**RE: Chavez Residence
7212 Osuna Rd. NE
Grading & Drainage Plan
Engineer's Stamp Date: 12/30/2024
Hydrology File: F19D040**

**WAIVER APPLICATION FROM STORMWATER
QUALITY VOLUME MANAGEMENT ON-SITE**

G1

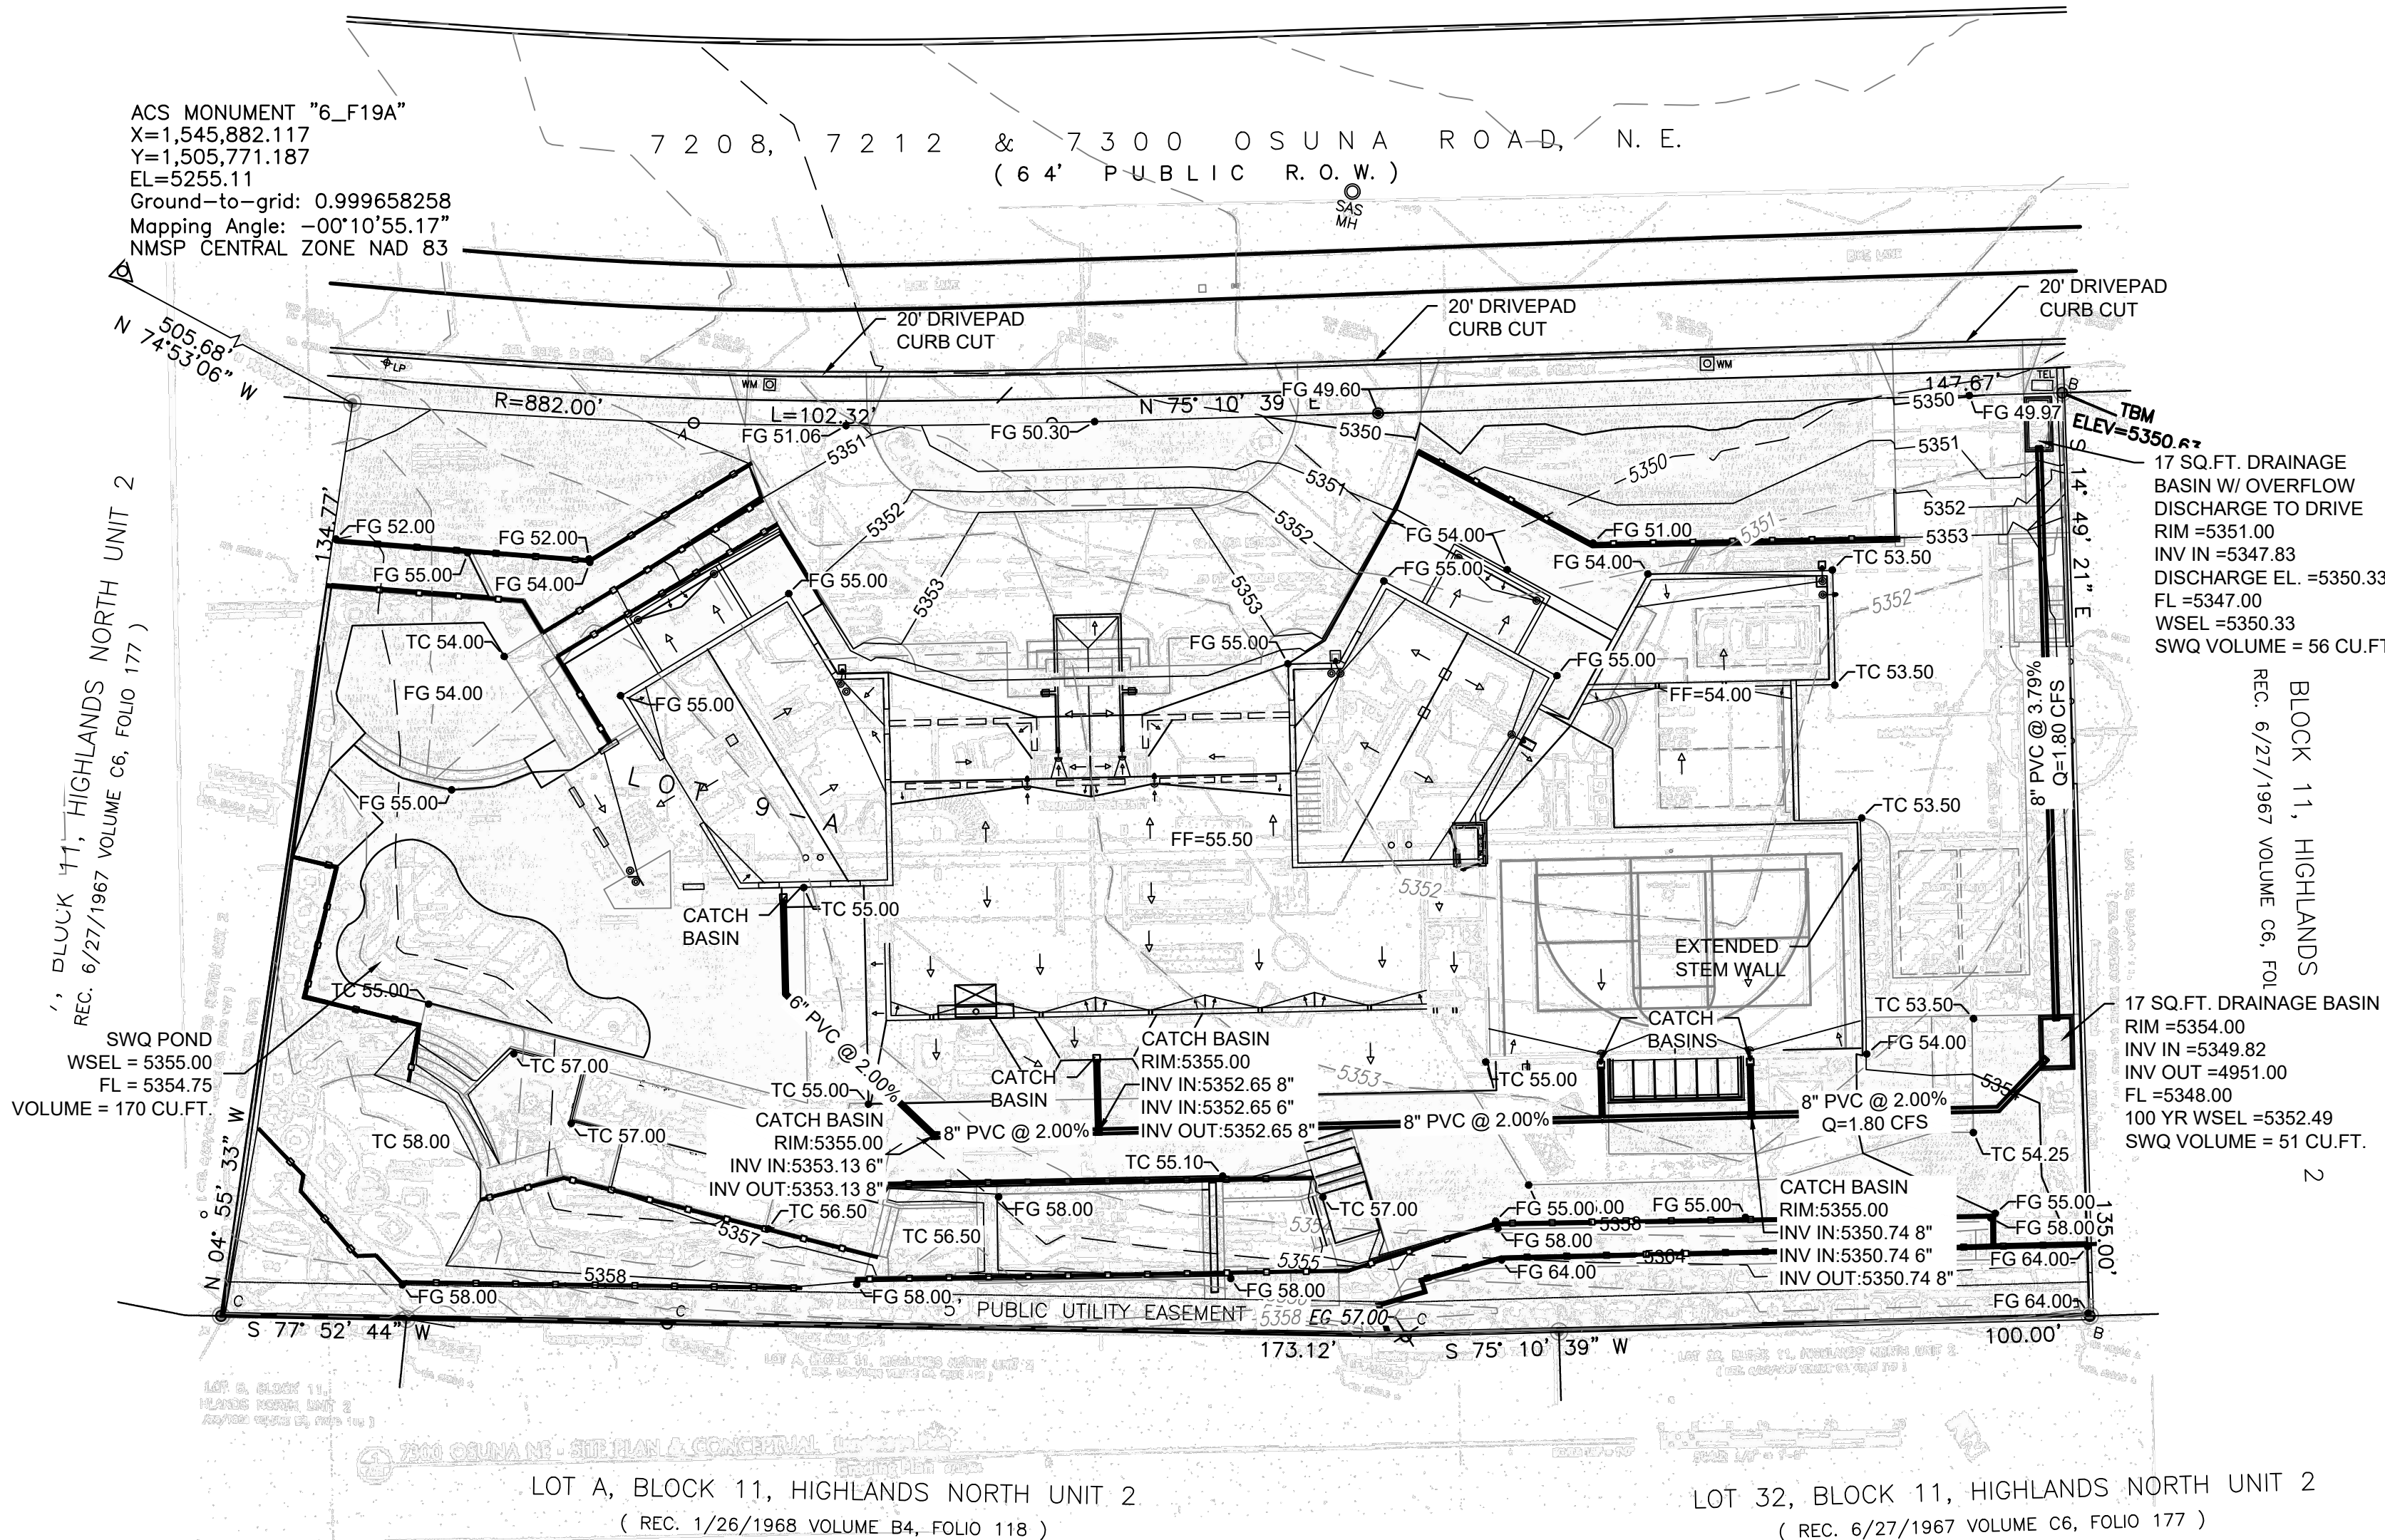
Based upon the information provided in your submittal received 12/30/2024, the Grading & Drainage Plan is **approved** for Building Permit. **Since this site is relatively flat and drains to the road, a pad certification is not needed for this project.** Please attach a copy of this approved plan in the construction sets for Building Permit processing along with a copy of this letter.

1. Engineer's Certification, per the DPM Part 6-14 (F): Engineer's Certification Checklist For Non-Subdivision is required.
2. Payment in Lieu (Amount = $123CF \times \$6/CF = \738 .) of onsite management of the SWQV must be made. Take three copies of the treasury deposit slip to the Treasury and then include one copy of the paid deposit slip when resubmitting.
